Data Detector: Issues Uncovered During Simulation

Glen Kramer

Problems #3 and #4

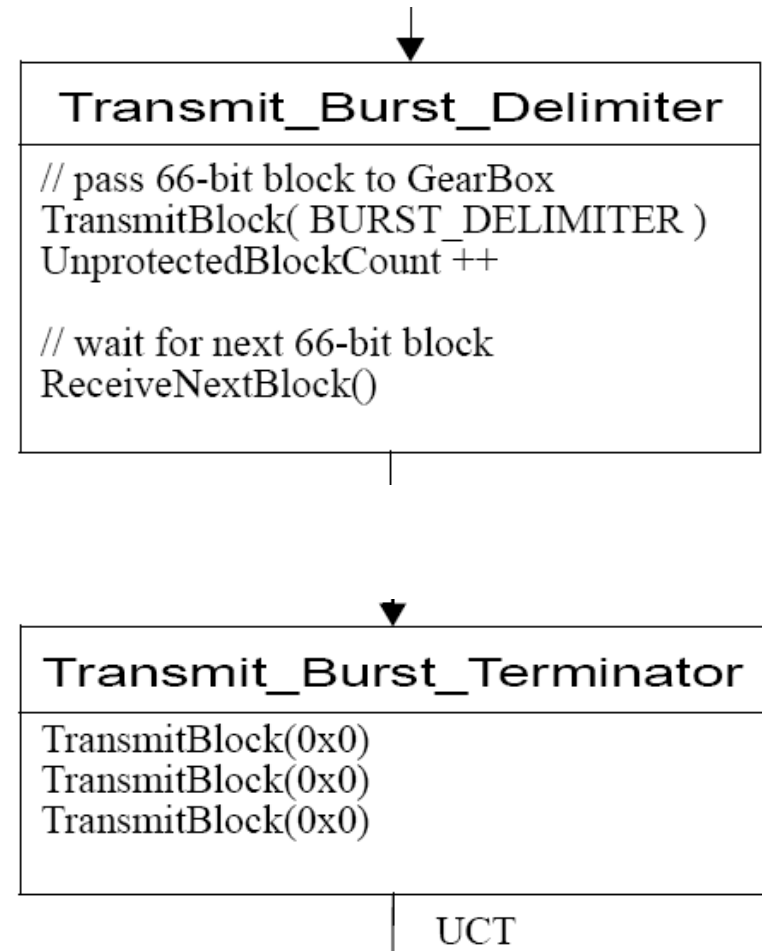
- Idles are not counted in state Transmit_Burst_Delimiter
- Idle Blocks and Unprotected Blocks should also be counted in state Transmit_Burst_Terminator
- In Transmit_Burst_Terminator state, 3 blocks should also be removed from FIFO_DD, or else outgoing rate will not be correct.

Figure 92–1—Data Detector, input process state diagram

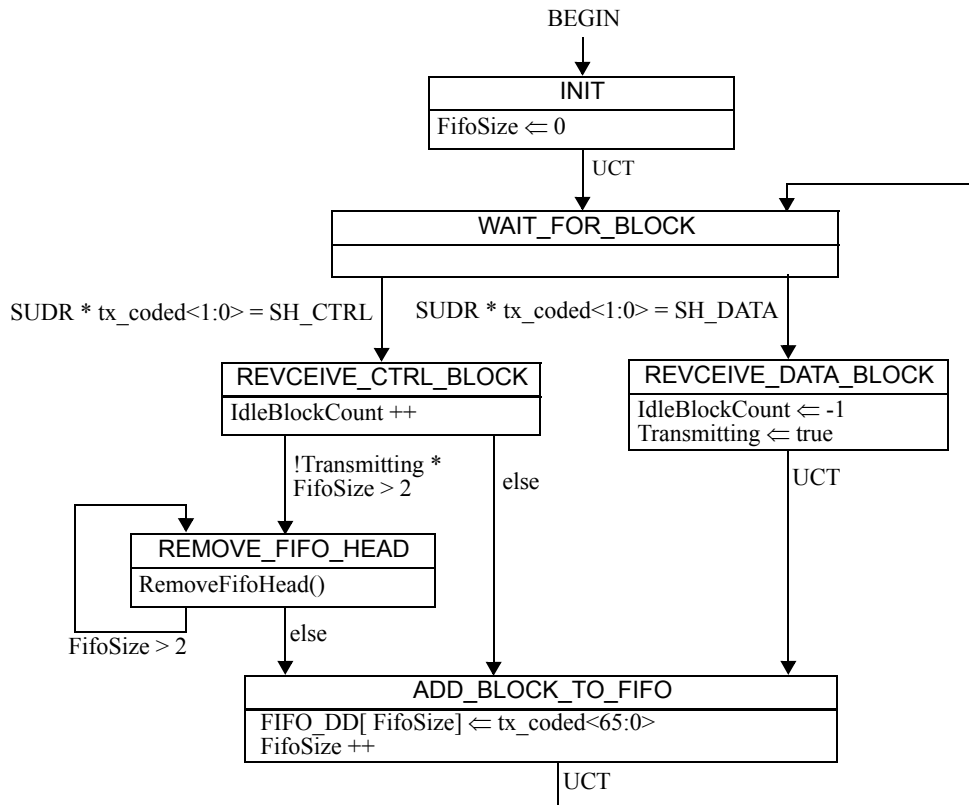
- Input process waits for a 66-bit block to arrive from the Scrambler.
- It counts the continuous run of Idle blocks (represented by IdleBlockCount).
 - If this value exceeds DELAY_BOUND, this means that the entire FIFO_DD contains only idles.
 - If arriving block is data block, the IdleBlockCount is reset to -1. This is because when a T-block received, IdleBlockCount will increment by one and show a true number of idles as 0.
- If the input block is a data block, Transmitting value is set to true to signal the output process to start turning the laser on (if it is currently off).

- The input process only keeps in the queue the data that will go into the FEC protected section of the burst.
- Between bursts, the Input process only keeps 3 blocks in the queue.
 - When a control block arrives, the head block is purged and the new block is appended.
- When the first data block arrives, the three blocks in the queue will be
 - FIFO_DD[0] = 1st protected IDLE
 - FIFO_DD[1] = 2nd protected IDLE
 - FIFO_DD[2] = block containing /S/
 - FIFO_DD[3] = just arrived data block

Figure 92-2—OLT Data Decoder, output process state diagram

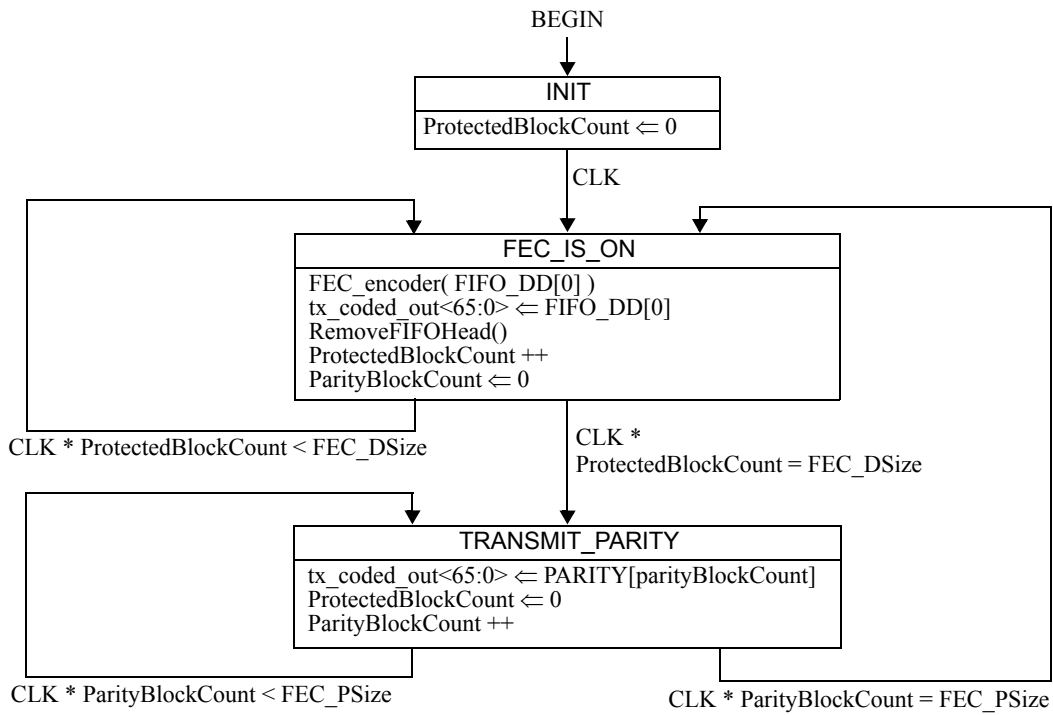
- Output process in the OLT only has states FEC_IS_ON and TRANSMIT_PARITY. These two states are identical to the corresponding ONU states.

Figure 92-3—ONU Data Decoder, output process state diagram

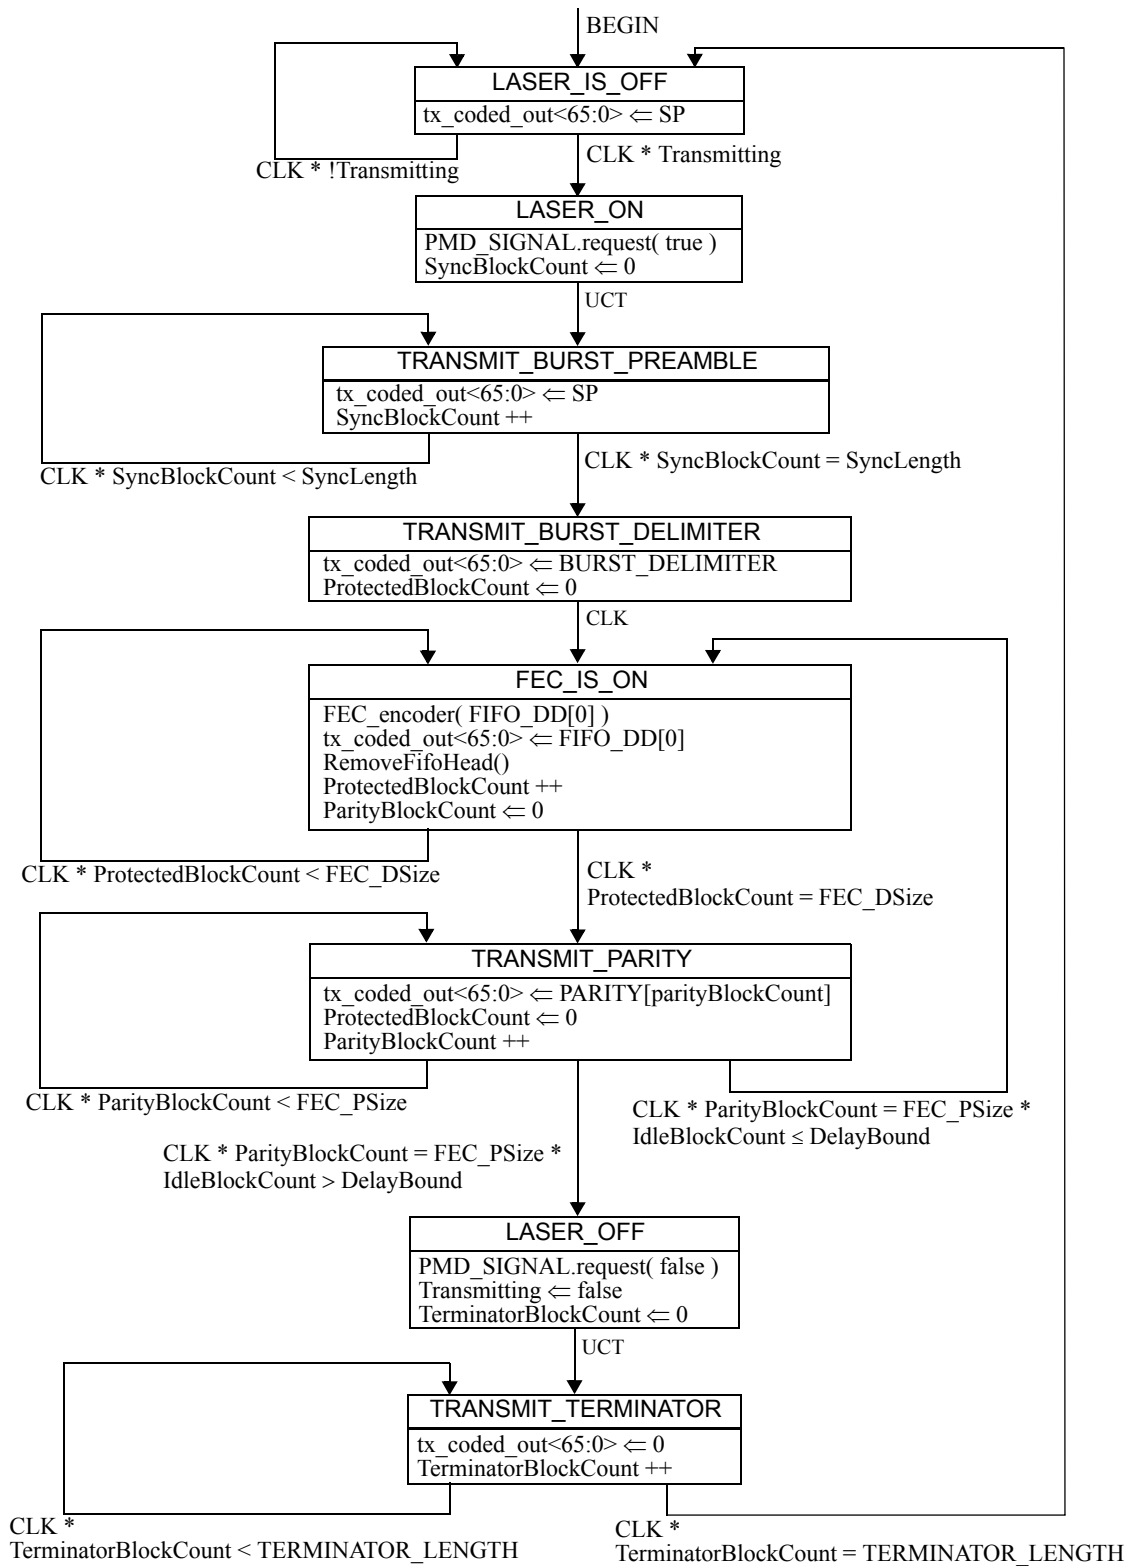
- Output process maintains the same states it had before, but state transitions now occur on edges of TX_CLK.
- The output process reads data from the FIFO_DD only in the FEC_IS_ON state.
- All other states generate output blocks on their own and at right times.
